MAINTENANCE BULLETIN

| AN/TPQ-37 RADAR SYSTEM W/WATER ENTRY RESOLUTION MOD KIT | FILE NO. 152 | REVISION: |
| SUBJECT: CIRCUIT CARD EXTRACTOR | DATE: 11/13/96 | CATEGORY: C-MAINT |

Figure 1

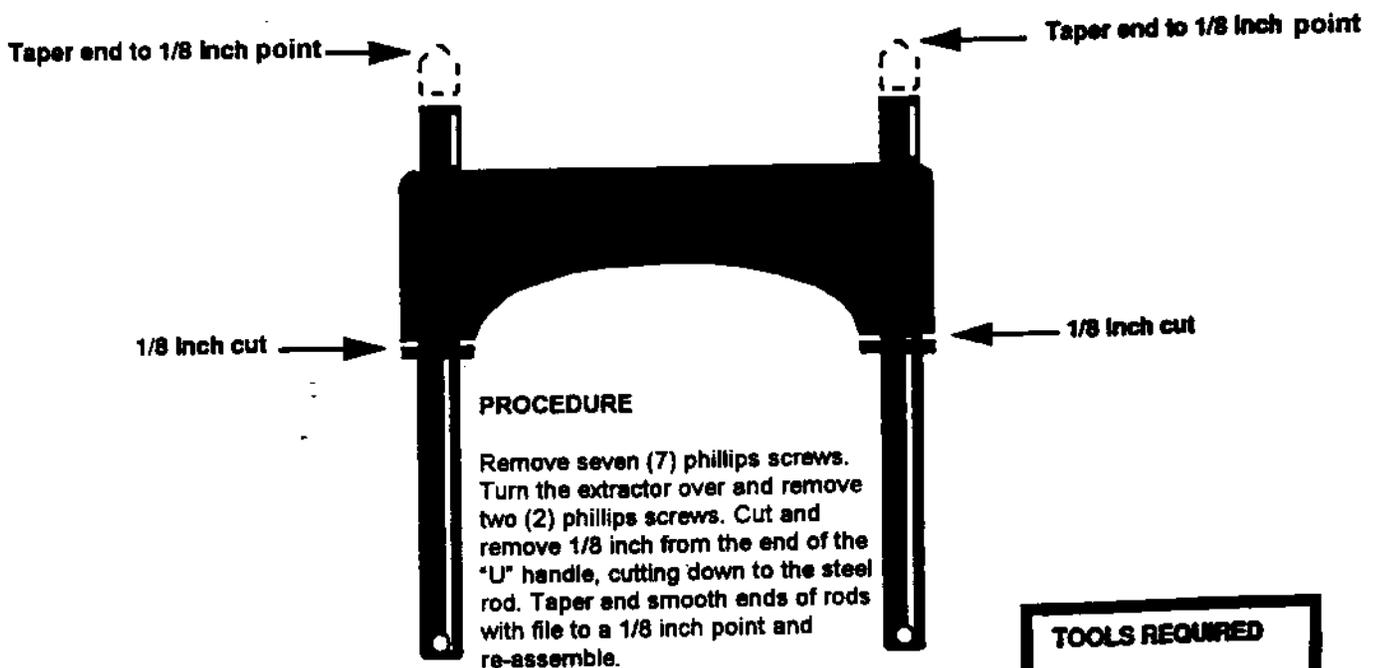
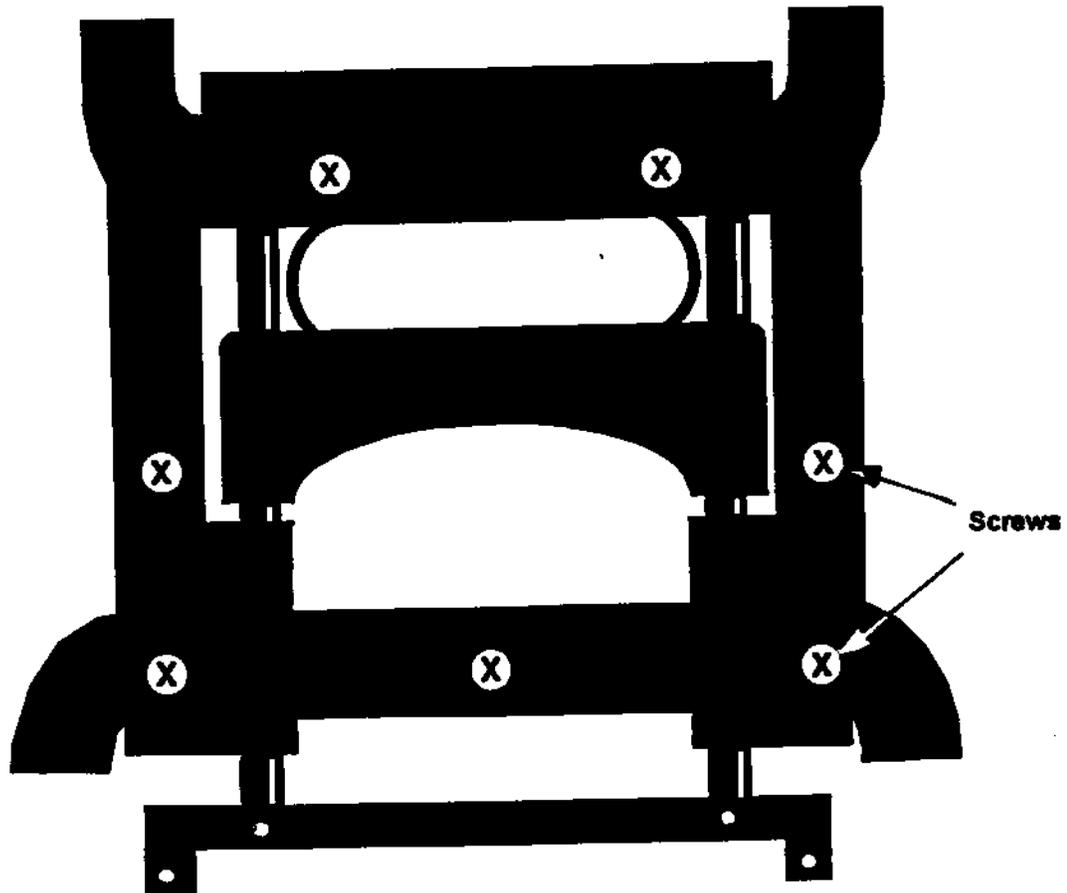
1. Reference: MWO 11-5840-355-50-3, "Modification of Radar Set, AN/TPQ-37 (V) Water Entry and Mechanical Upgrade".
2. Background: As part of the Water Entry Resolution effort on the AN/TPQ-37 Radar System, three (3) mounting frames were added around the circuit card bays on the front of the BSU card rack. The addition of these frames increased the distance which the card extractor needs to reach in order to engage a card for removal, therefore, creating a requirement for a new/modified card extractor.

4. The purpose of this maintenance bulletin is to inform maintenance personnel that Circuit Card Extractor, NSN 5999-01-253-8643, can be modified in order to be used on the AN/TPQ-37 FIREFINDER Radar System with Water Entry Resolution Mod Kit, card extractor modification procedures are shown in Figure 1.

MODIFICATION OF CIRCUIT CARD EXTRACTOR

Figure 2

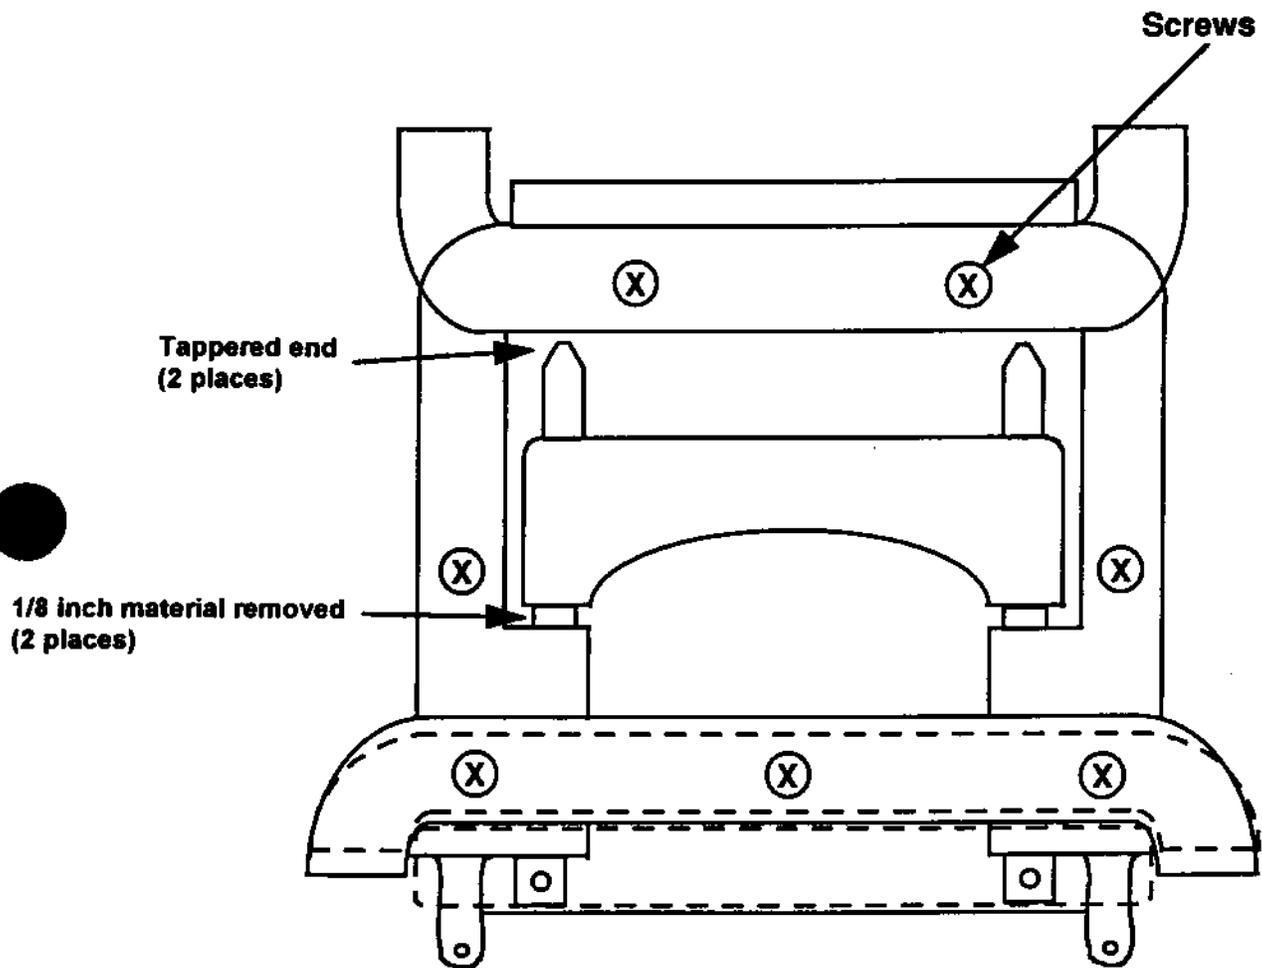
5. The attached rough drawing (Figure 2), shows the modified extractor.
6. This circuit card extractor modification will resolve the problem that occurs when the Water Entry Mod is applied to the AN/TPQ-37 Radar Systems.

3. Circuit Card Extractor, NSN 5998-01-436-7849, P/N 3013521, CAGE 65534, is the new modified version to be requisitioned for use on the AN/TPQ-37 FIREFINDER Radar Set with the Water Entry Resolution Mod Kit applied.
